MODEL: J Series	TYPE: Field Change Program	SECTION/GROUP: 07-Electrical	DATE: 06/10/2019
---------------------------	--------------------------------------	--	----------------------------

Motor Coach Industries ("MCI") has become aware that on MY2018-J4500 coaches, the potential exists for water intrusion into the coach in the stepwell, dash and driver area from the front marker lights.

2.0 Removing the front marker lights, gaskets, and wellnuts

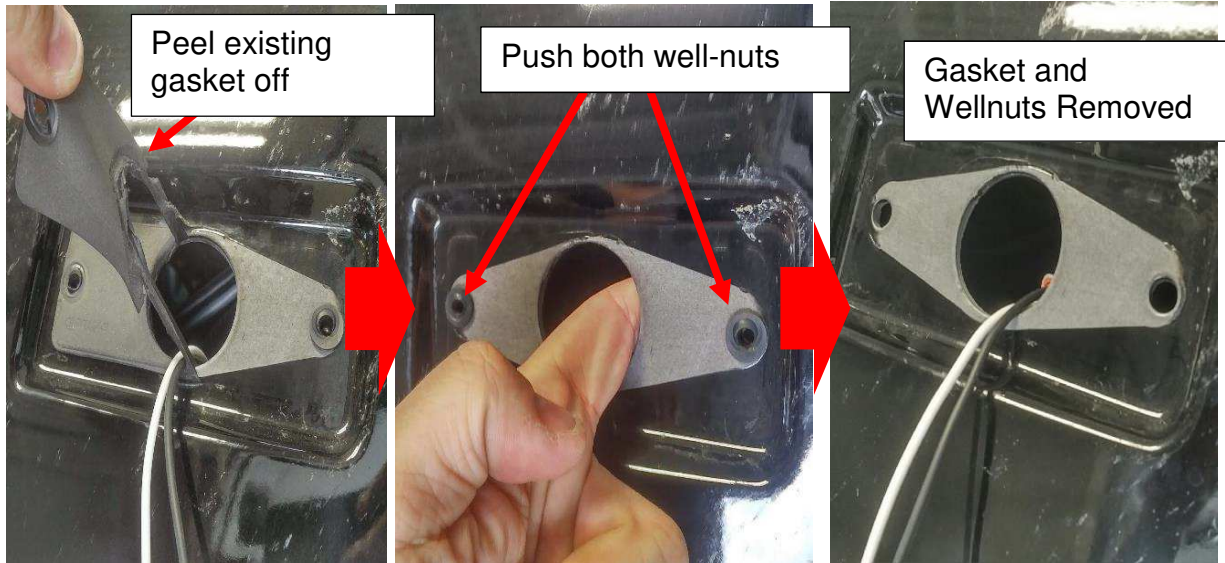
Remove the 7 front marker lights from the front of the vehicle by removing and discarding the two 8-32 screws on each light.

Disconnect the marker light. Do not let the Deutsch connector fall into the vehicle.

Peel off the existing gaskets, then push the existing wellnuts out of the holes. Discard old gaskets and wellnuts.

3.0 Installing the well-nuts

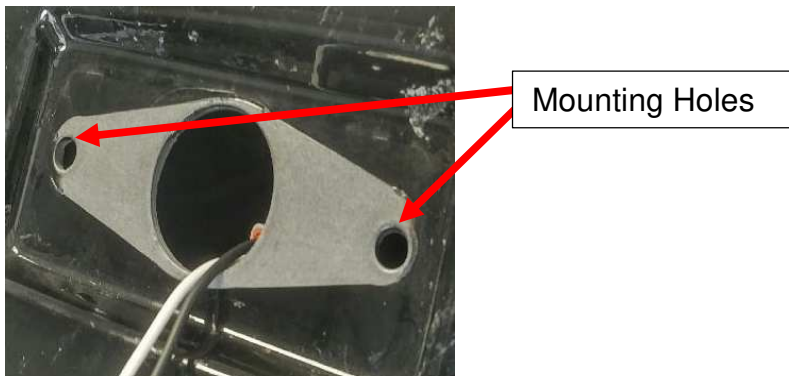
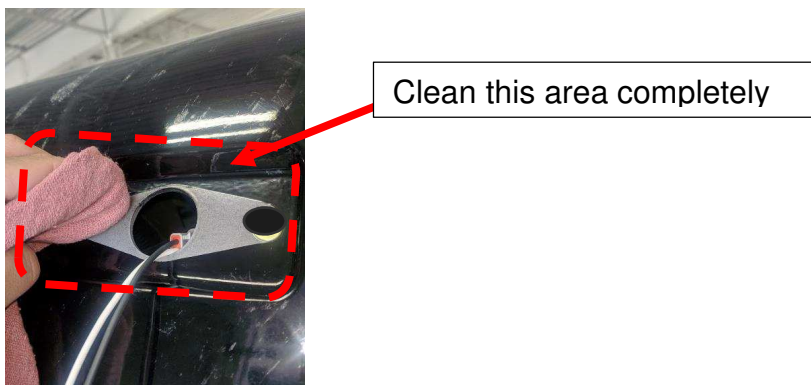
Before installing well nuts, enlarge the mounting holes using 3/8 reamer.

Using warm water and soap, or a suitable adhesive remover, clean the marker light area completely.

Apply 2 drops of Loctite, 21-7212-18, to the well nuts, 19-03-0602, and insert them in the mounting holes. Firmly press the well nuts into position into the mounting holes and let the adhesive dry for 1 minute.
